IN HOUSE REJECTION: KAIZEN

4a.1 Appearance not Good

Physical Phenomenon : **Weld spot indentation**
Due to : Man / Machine / **Method** / Material

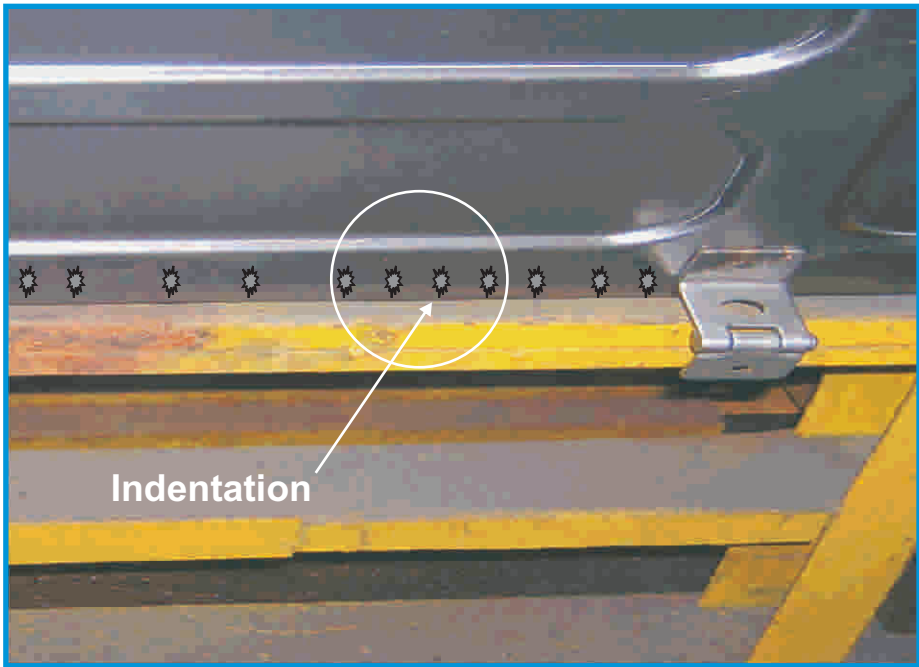
No positive support to part while spot welding.

Root Cause : Easy to deflect.

Kaizen Idea : Difficult to deflect

Kaizen : Positive support provided to avoid deflection while spot welding.
